PRODUCT  
SUPPORT  
BULLETIN # 363

**SUBJECT:** RAD – 38-50-2801 and 38-50-2951 spindle threads

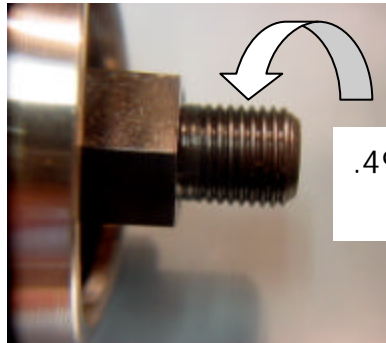
**Undersize** spindle threads of the Right Angle Drive assembly can **cause strippage of the internal 'female' threads of a Chuck** and the external 'male' threads of the RAD spindle on a **corded** 1/2" 'D'-Handle Hole-Shooter™ Right Angle Drill when drilling 2-9/16" or larger holes.

**Undersize** spindle threads will have  
a 'flattened' thread appearance

.490" is minimum 'major' [outside] thread  
diameter for a good spindle
